## 7.2 Reactor Protection (Trip) System (RPS)—Instrumentation and Controls

The information in this section of the reference ABWR DCD, including all subsections, tables and figures, is incorporated by reference with the following departures and supplements.

STD DEP T1 2.3-1 (Table 7.2-1, 7.2-2, Figures 7.2-2, 7.2-6, 7.2-9, 7.2-10)

STD DEP T1 3.4-1 (Figures 7.2-2, 7.2-9, 7.2-10)

Figure 7.2-2 Reactor Protection System Equipment Arrangement (From Sensors Through Trip Actuators)

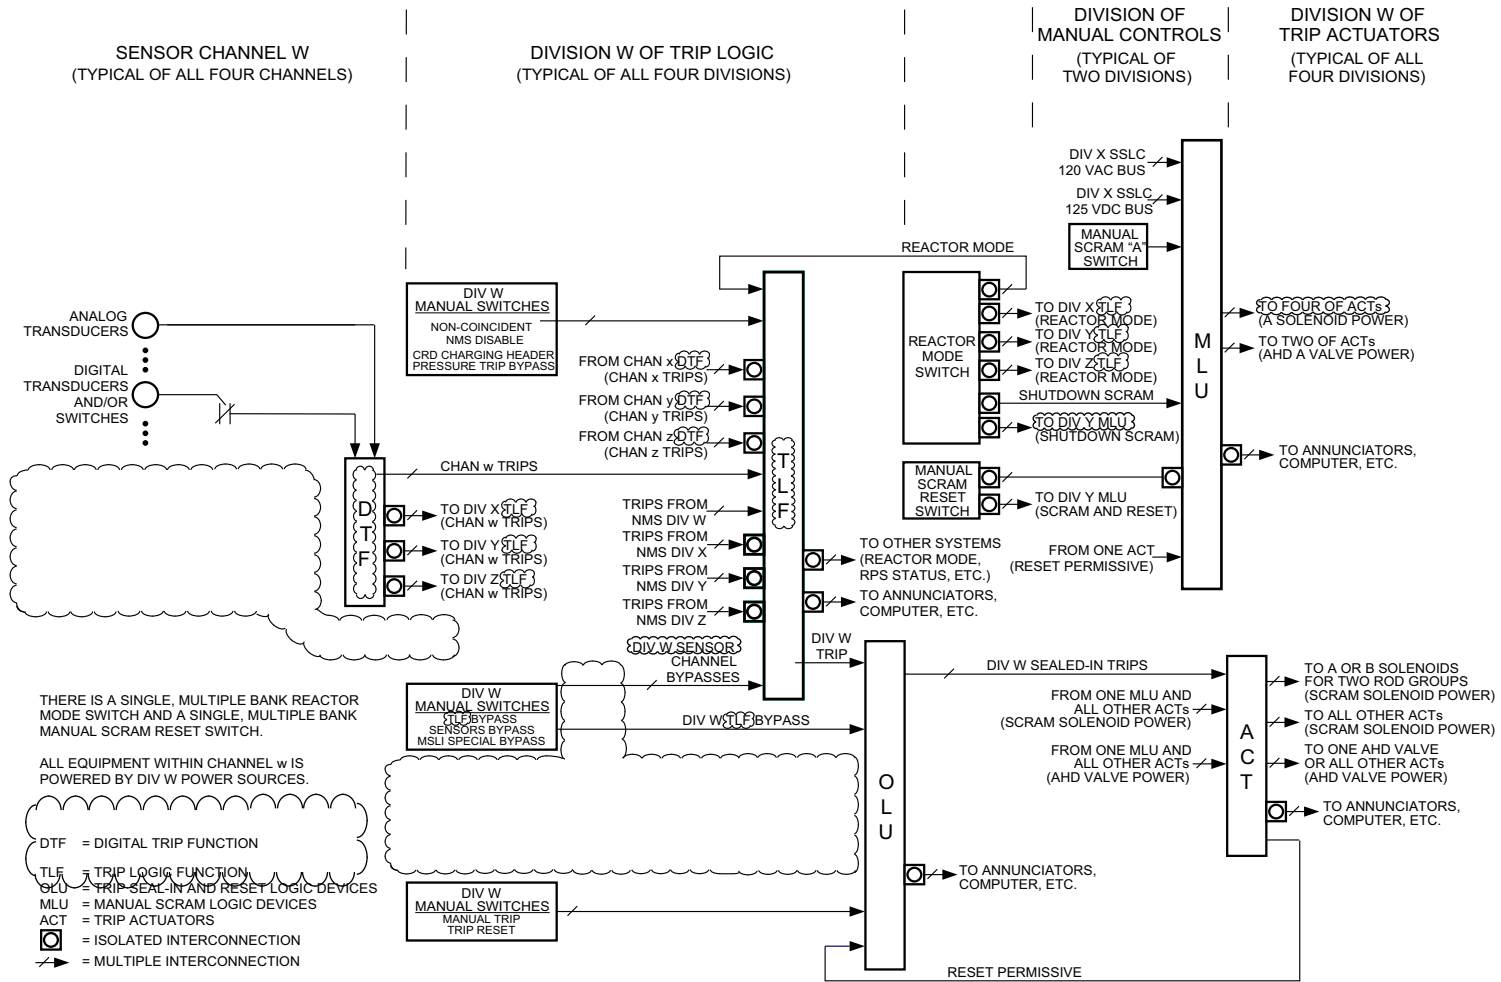
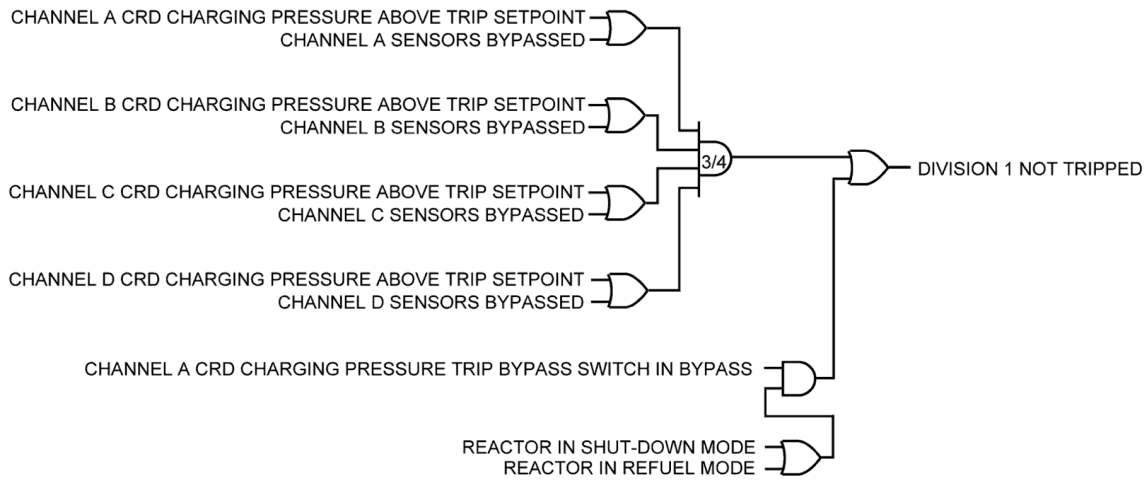
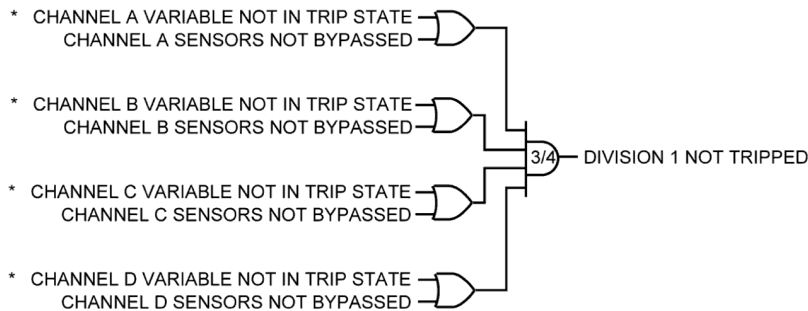
The RPS equipment is divided into four redundant divisions of sensor (instrument) channels, trip logics and trip actuators, and two divisions of manual scram controls and scram logic circuitry. The sensor channels, divisions of trip logics, divisions of trip actuators and associated portions of the divisions of scram logic circuitry together constitute the RPS scram and air header dump (backup scram) automatic initiation logic. The divisions of manual scram controls and associated portions of the divisions of scram logic circuitry together constitute the RPS scram and air header dump manual initiation logic. The automatic and manual scram initiation logics are independent of each other. RPS equipment arrangement is shown in Figure 7.2-2.

Equipment within a sensor channel includes primarily sensors (transducers or switches), ~~multiplexers and digital trip modules (DTMs)~~ trip functions (DTFs). The sensors within each channel monitor plant variables (Subsection 7.2.1.1.4.2) ~~and send either analog or discrete output to remote multiplexer units (RMUs) within the associated division of Essential Multiplexing System (EMS) the DTF.~~ Each division of the EMS performs analog to digital conversion on analog signals and sends the digital or digitized analog output values of all monitored variables to the DTF within the associated RPS sensor channel. The ~~DTM DTF~~ in each sensor channel compares individual monitored variable values with trip setpoint values and for each variable sends a separate, discrete (trip/no trip) output signal to all four divisions of trip logics.

Four independent sensor channels monitor the various process variables listed in Subsection 7.2.1.1.4.2. The redundant sensor devices are separated so that no single failure can prevent a scram. The arrangement of RPS sensors mounted in local racks is shown in Figure 7.2-2. Locations for local RPS racks and panels are shown on the instrument location drawings provided in Section 1.7. ~~Divisional separation is also applied to the Essential Multiplexing System (EMS) D which provides data highways for the sensor input to the logic units. Physically separated cabinets are provided for the four scram logics. Fiber optic cable routing from remote multiplexing units (RMUs) remote digital logic controllers to control room equipment is shown in raceway plans provided by reference in Section 1.7.~~ The criteria for separation of sensing lines and sensors are discussed in Section 7.1.
